SERVICE BULLETIN

APPLICABILITY: 2015MY Legacy and Outback Models
SUBJECT: Wind “Rushing” or “Fluttering” Sound from
“B” Pillar Area

NUMBER: 12-185-15
DATE: 05/21/15

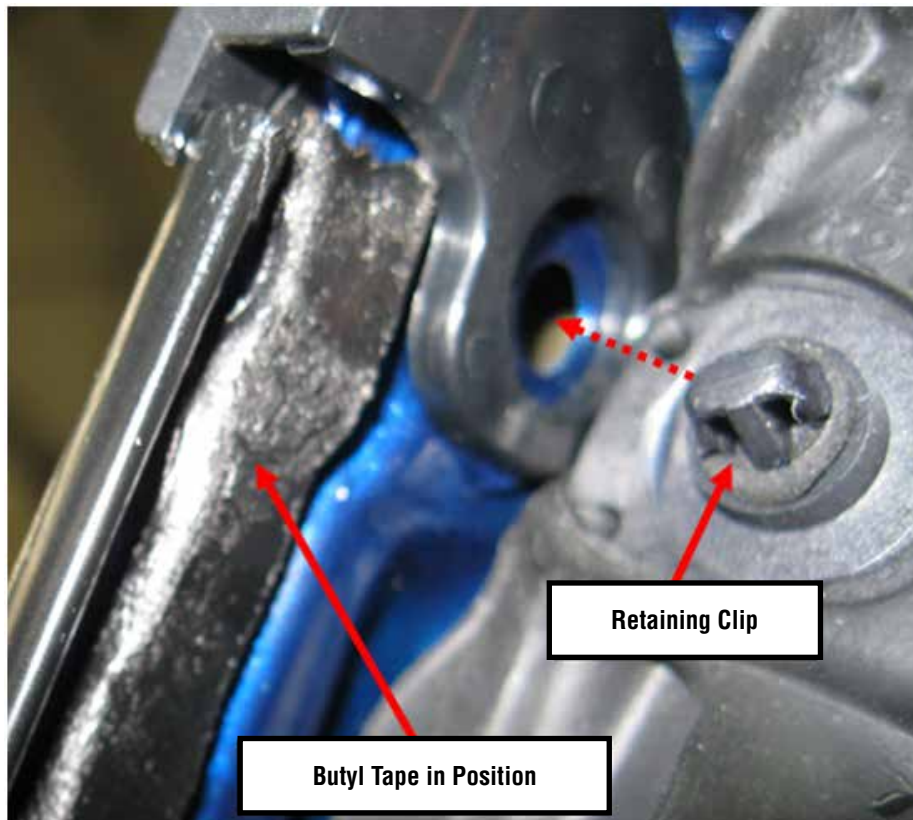
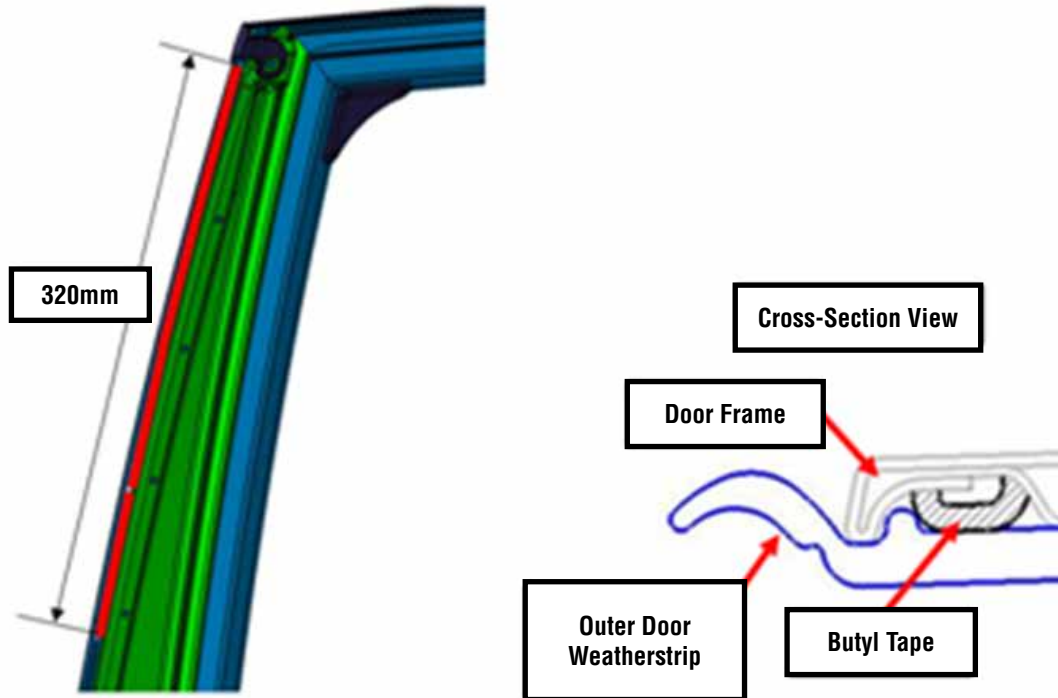
Use a plastic trim tool to release the plastic retaining clip located at the top front corner of the door. **CAREFULLY** pull back the weatherstrip to gain access to the area where the butyl tape will be applied.

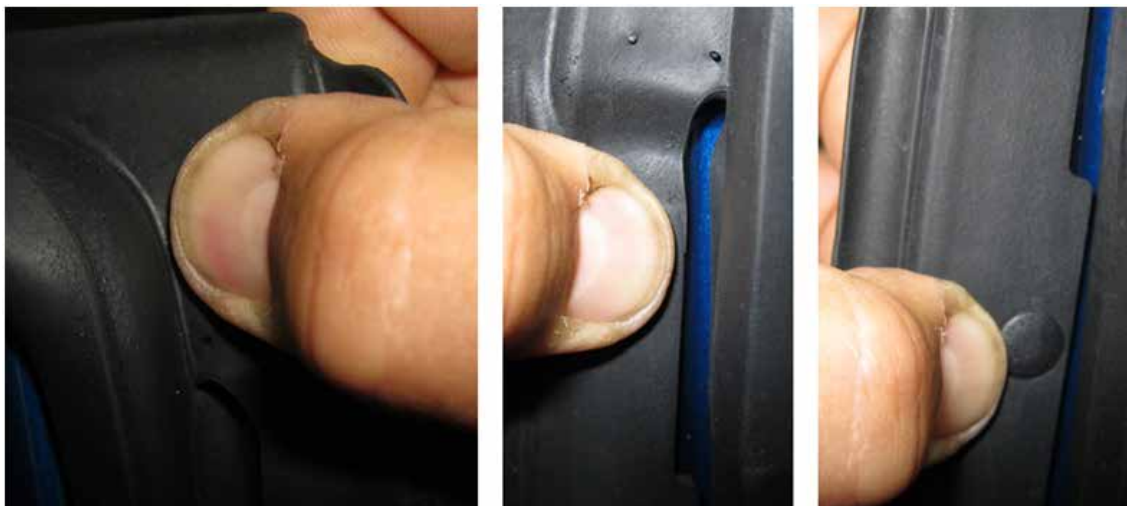
If you find a piece of butyl tape already installed (approximately 80mm in length) from a prior repair, it will need to be **CAREFULLY** removed. If there is already a 320mm long piece of butyl tape installed, the sound is likely coming from another source and no further repair should be attempted in this area. If the butyl tape needs to be removed, always clean the area where the new tape will be applied with a mild solvent on a clean shop cloth afterward. After drying the area completely, apply the new 320mm length of butyl tape to the door frame as indicated in the illustrations and photo below.

After the butyl tape is applied, refit the door frame weatherstrip and make sure the retaining clip “clips” back into the hole as shown to properly secure and position it. Work the weatherstrip onto the butyl tape with your thumbs making sure it is smooth and any bumps or high spots have been worked out.

To complete the procedure, always make sure the front edge of the weatherstrip is properly tucked in behind the chrome outer molding as shown in the photos below.
